Project No. 12091-01

**Subject: Preliminary Geotechnical Evaluation and Response to City Review Comments for Proposed San Pedro Distribution Center, 1599 W. John S. Gibson Boulevard, Los Angeles, California**

## **5.0 RESPONSE TO CITY REVIEW COMMENTS**

SHEET 3  
SHEET 2

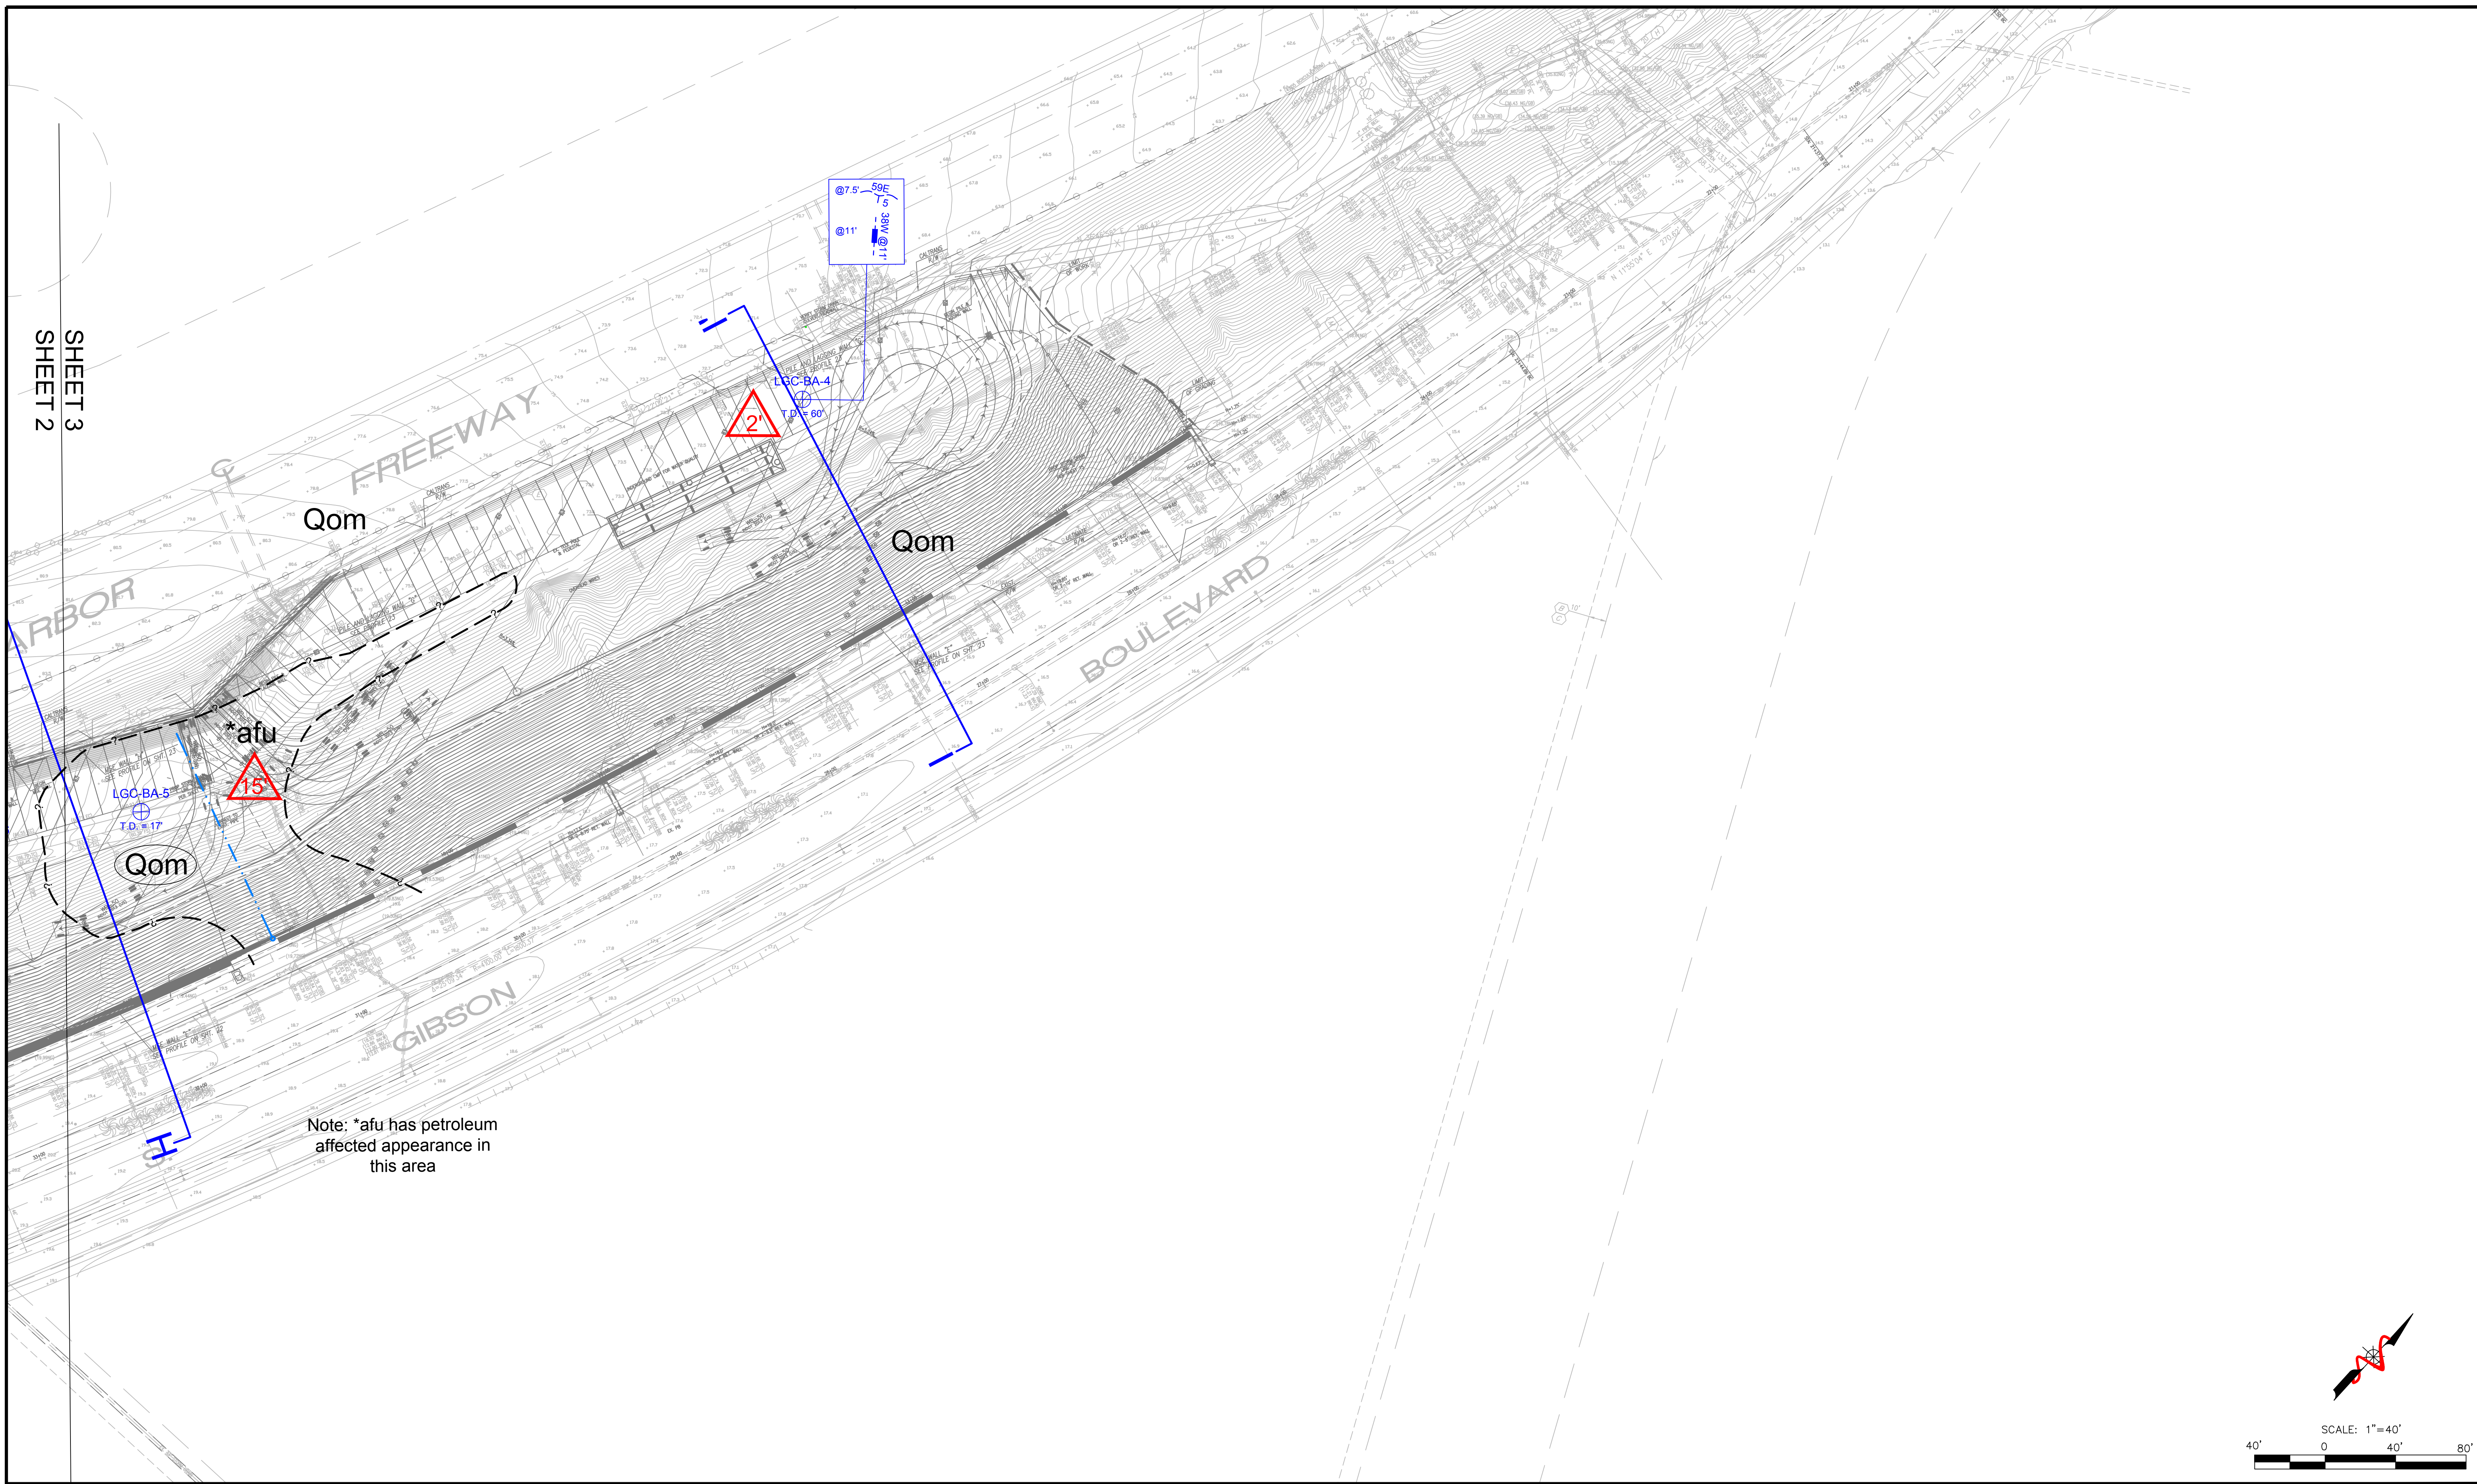
“No map was provided with the current update report reflecting the proposed site conditions. Provide recommendations and revise the plan(s) and cross sections(s) for providing the required building setback from the toe of the ascending slope as specified by Code Section 1808.7.1.”

Refer to the attached Geotechnical Map (Sheets 1 through 3). No building structures are planned for the site.

**Geotechnical Cross Sections A-A' Through E-E'**

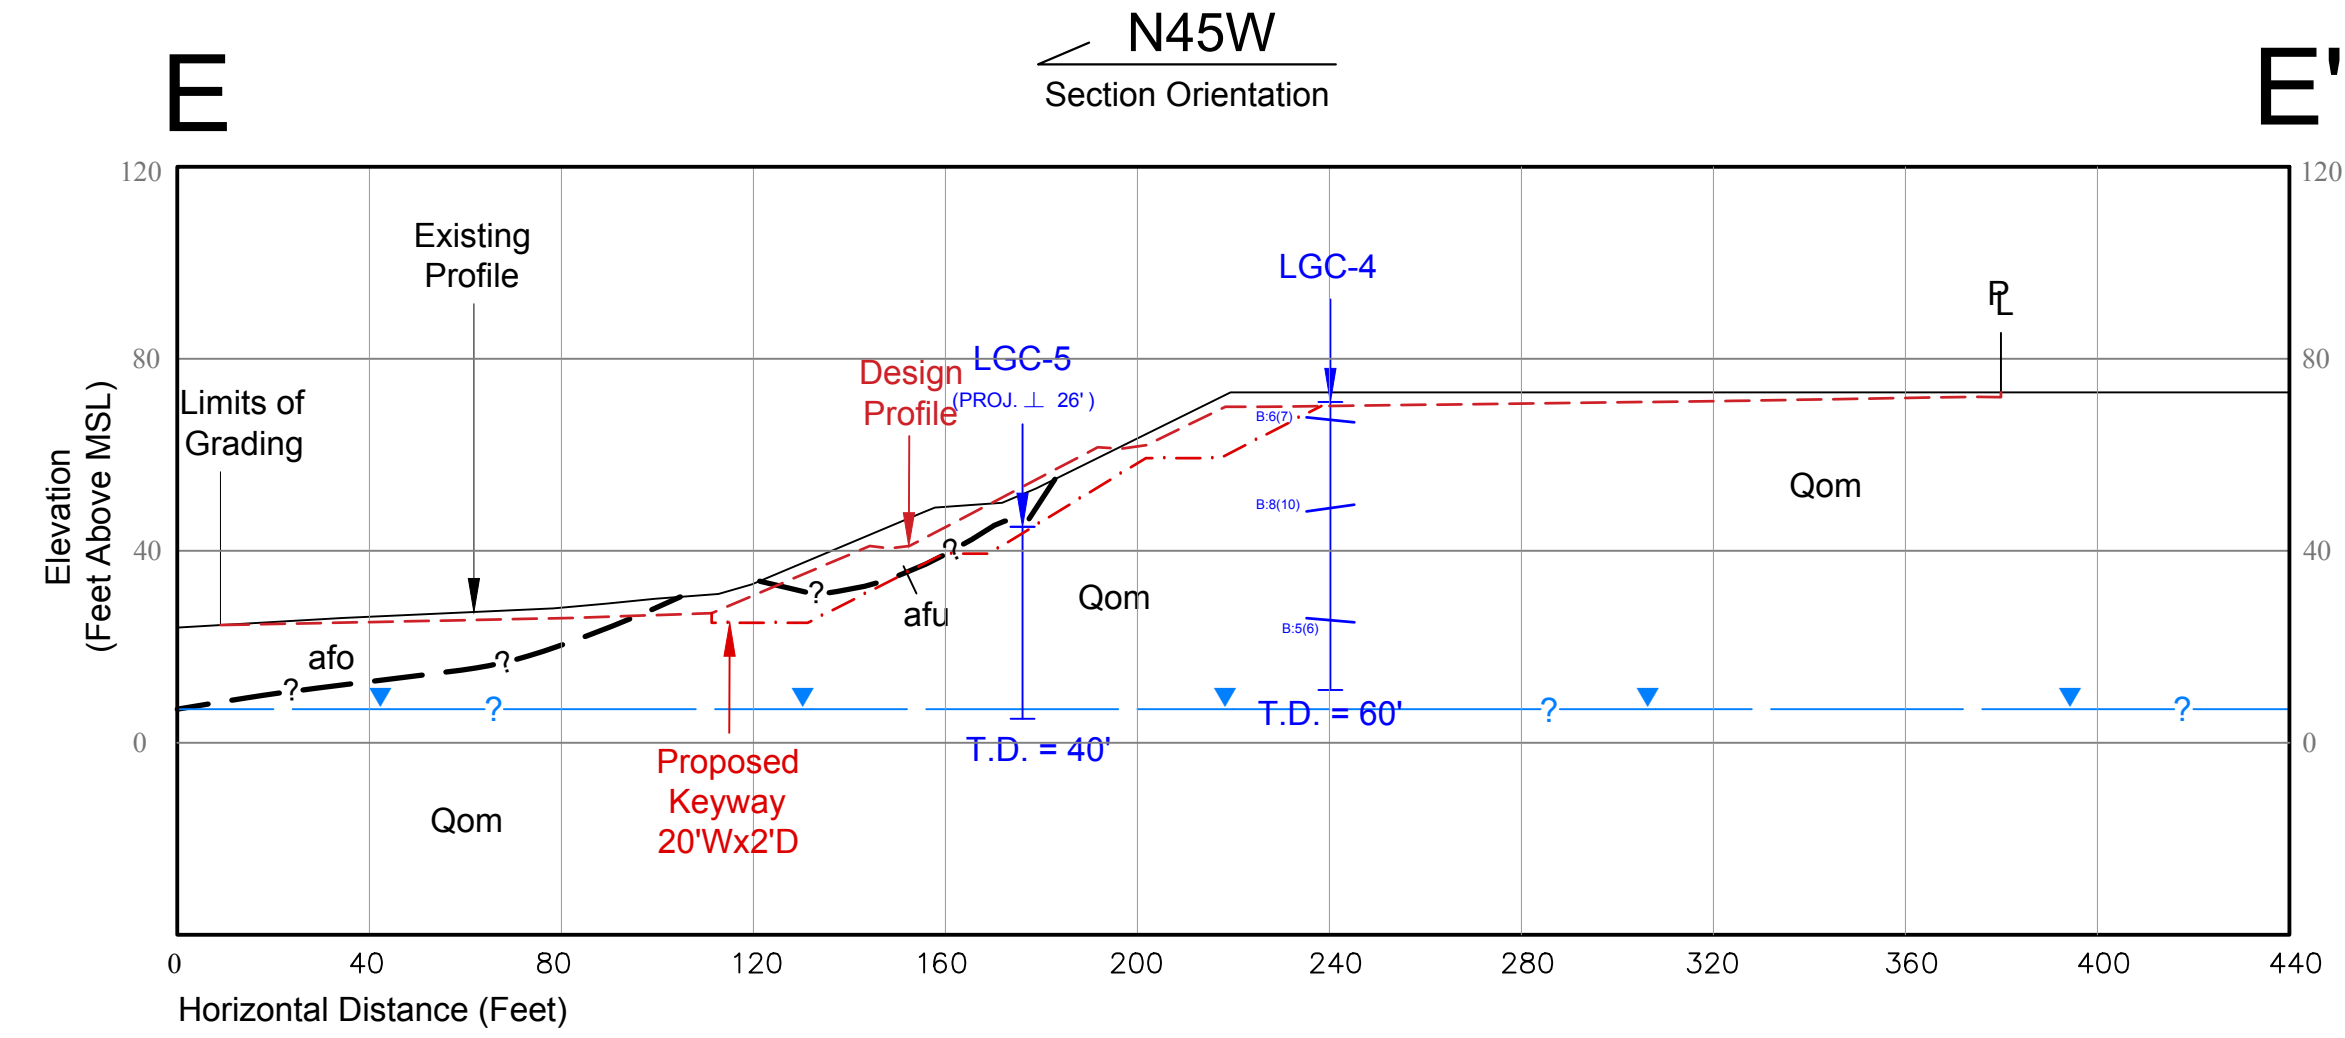
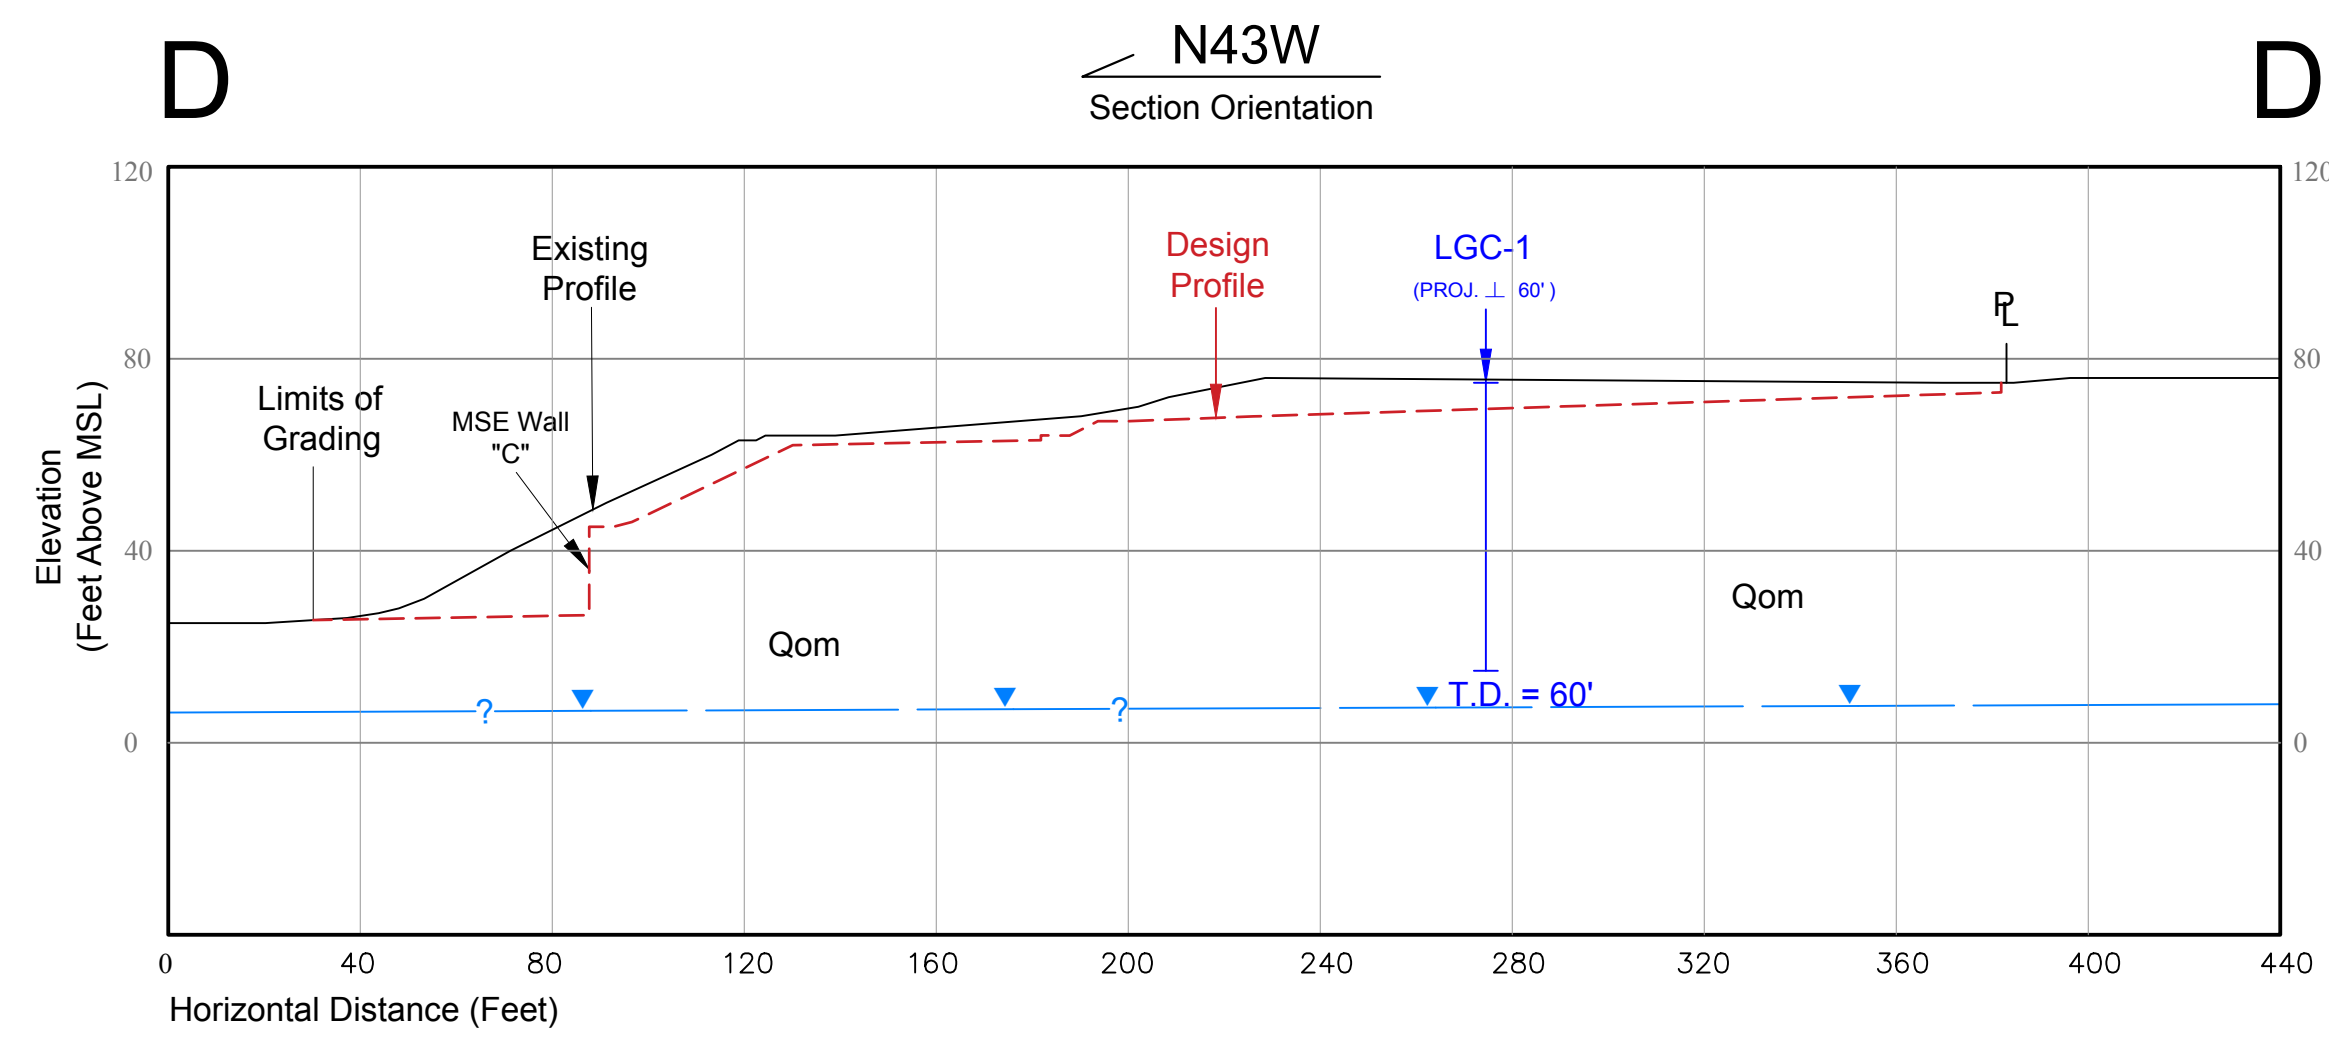
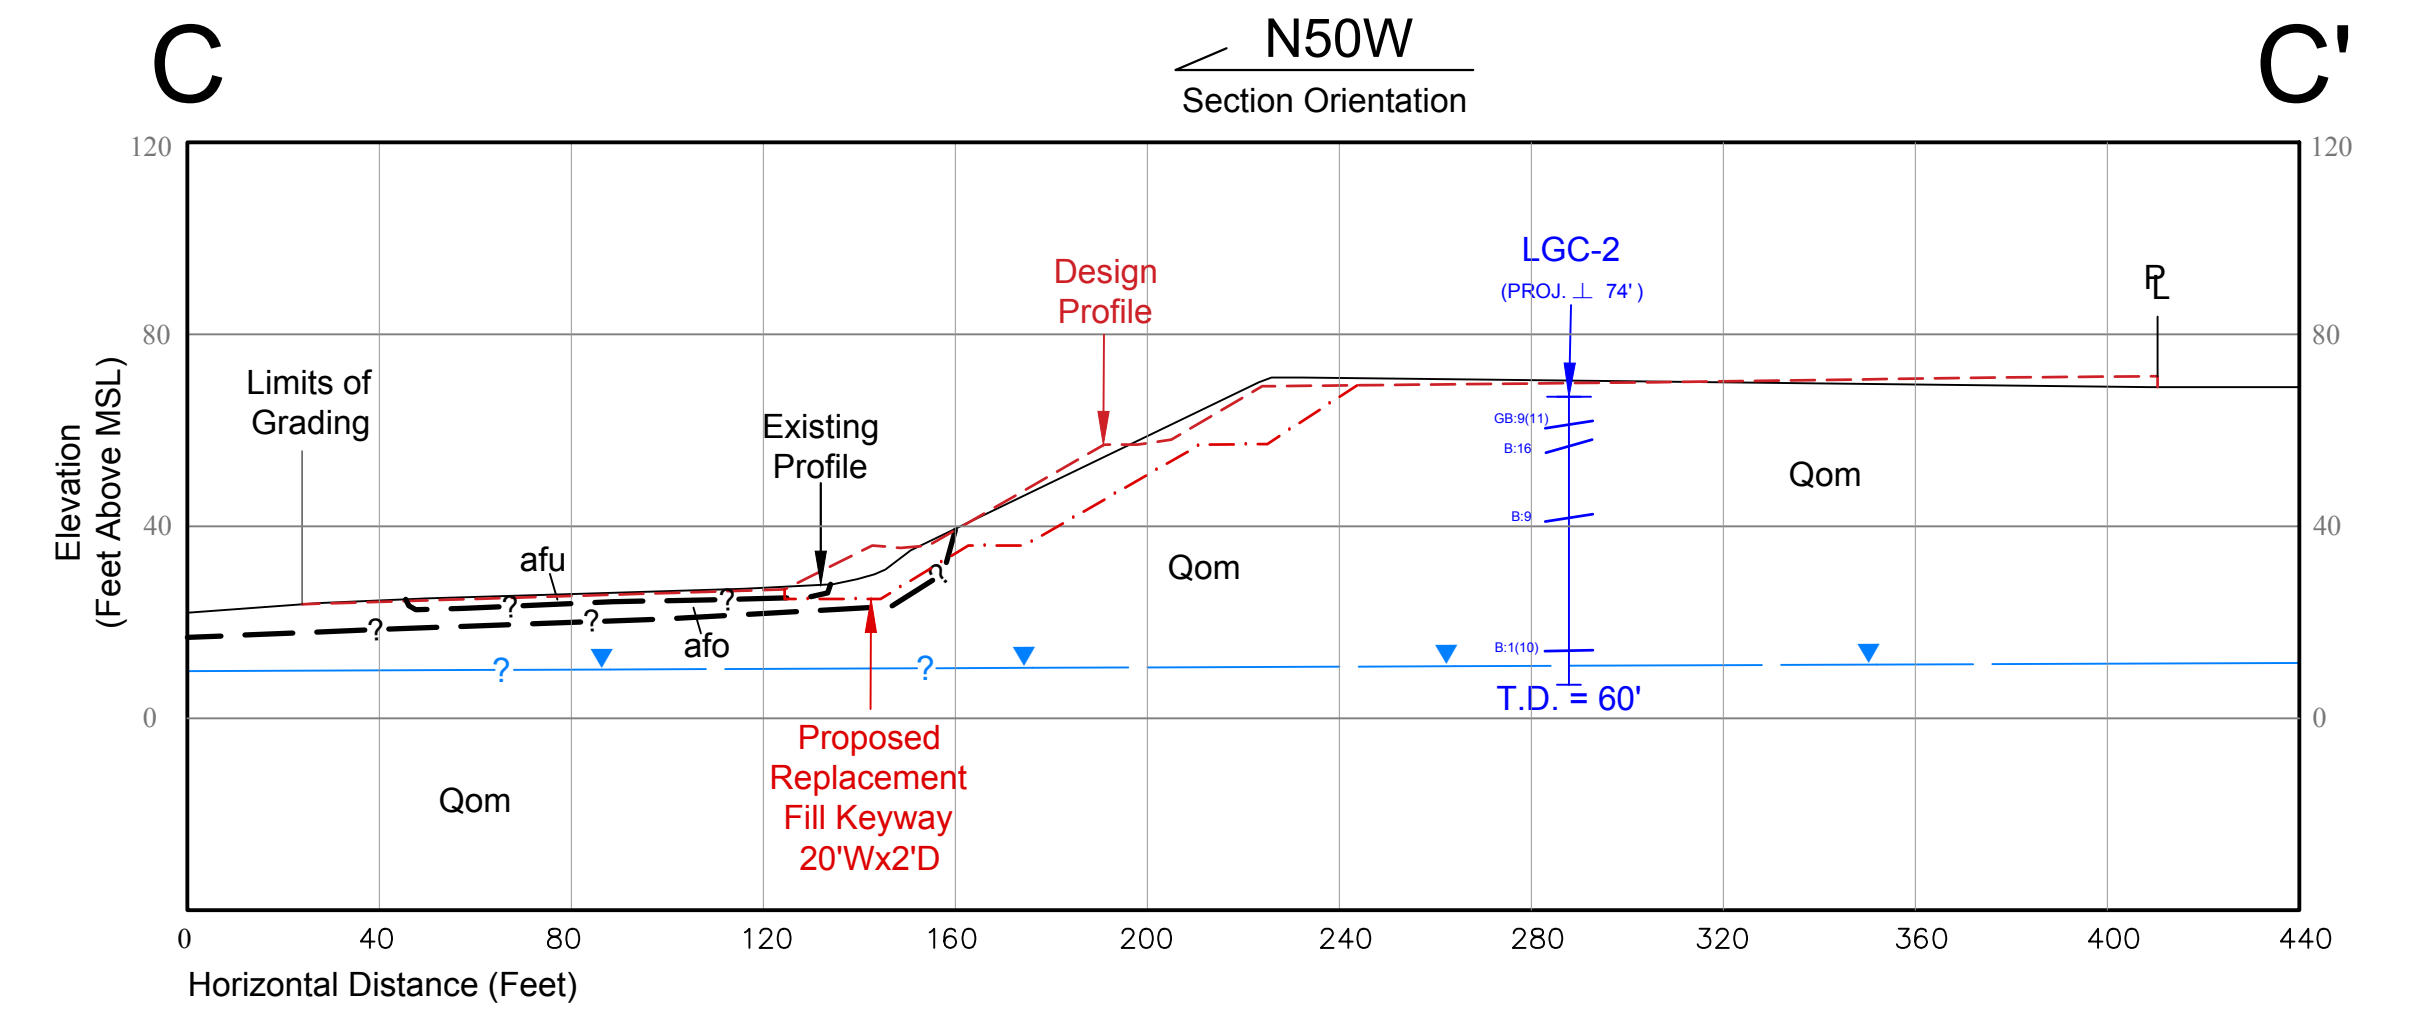
“Provide a geologic map and cross sections that are based upon conceptual grading or site development plans, to illustrate all proposed and existing contours relative to the planned grading and/or construction, along with all off-site slopes and conditions that could adversely affect the stability or safety of the site (7006.3.2). The geologic map and cross sections shall depict the top and bottom of slopes; lithologic contacts; bedding attitudes; locations of slumps, landslides, or faults relative to the subject site; existing and proposed topographic profiles; existing and proposed structures; and, required Code setbacks. (7006.3.2)”

Refer to the attached Geotechnical Map and Geotechnical Cross Sections (Sheets 1 through 5). No building structures are planned for the site.
